**Attachment XII  
Site Specific Sampling and Analysis Plan  
Groundwater Remedial Investigation  
TNT and Red Water Ponds Areas**

**Former Plum Brook Ordnance Works, Sandusky, Ohio**

**RESPONSE TO COMMENTS  
U. S. ARMY CORPS OF ENGINEERS  
ON ATTACHMENT XII, SITE SPECIFIC SAMPLING AND ANALYSIS PLAN,  
GROUNDWATER REMEDIAL INVESTIGATION, TNT AND RED WATER  
PONDS AREAS, FORMER PLUM BROOK ORDNANCE WORKS  
SANDUSKY, OHIO  
(Draft dated June 2001)**

*Response to U. S. Army Corps of Engineers on Attachment XII  
Comments from CELRN-EC-R-D, June 2001.*

Figure 2-1

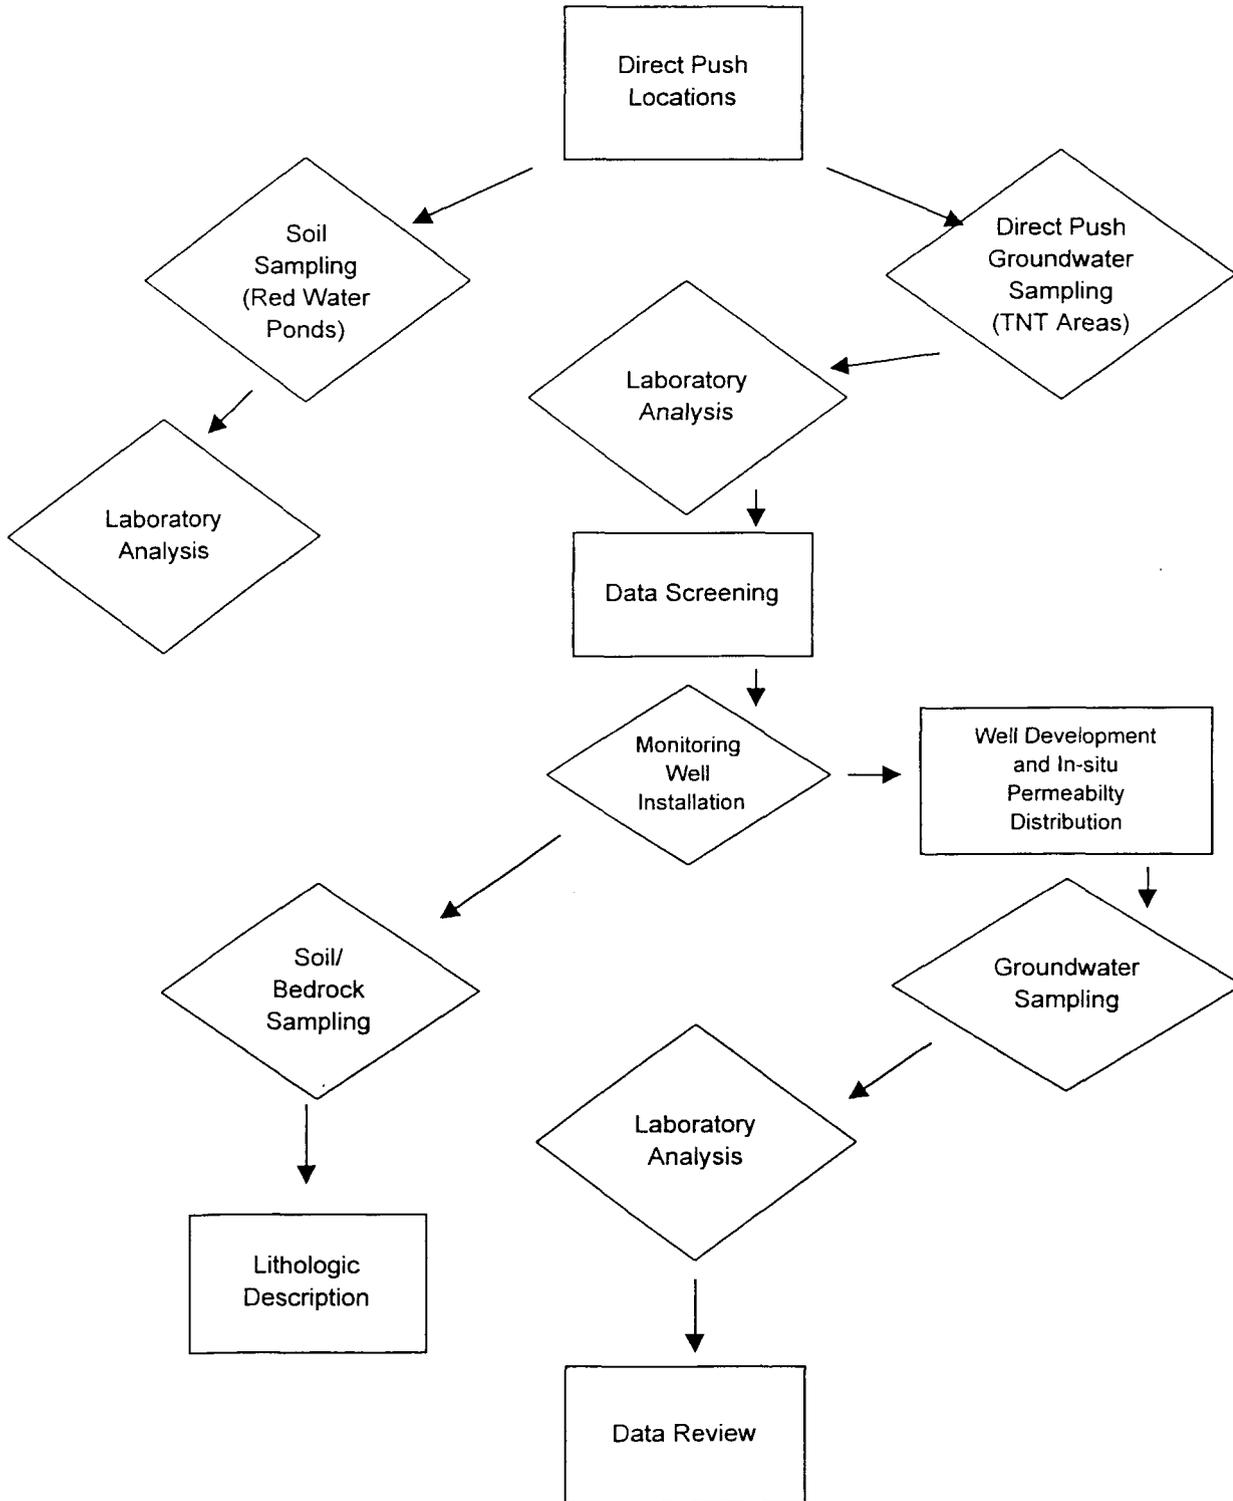
- Response 1:** MK-MW12 has been included on Figure 1-5.
- Comment 2:** Page 2-3, Section 2.4.4, last sentence: The copy of the SSAP I reviewed has no Figure 2-2. Perhaps the reference was intended to refer to the flow chart, Figure 2-1.

- Response 2:** Yes, the reference was intended to be to Figure 2-1 and not to Figure 2-2. Corrections have been made to the text.
- Comment 3:** Page 3-1, Section 3.0: Isn't the number of new and existing overburden wells to be sampled 23 (18 non-background + 5 background)?
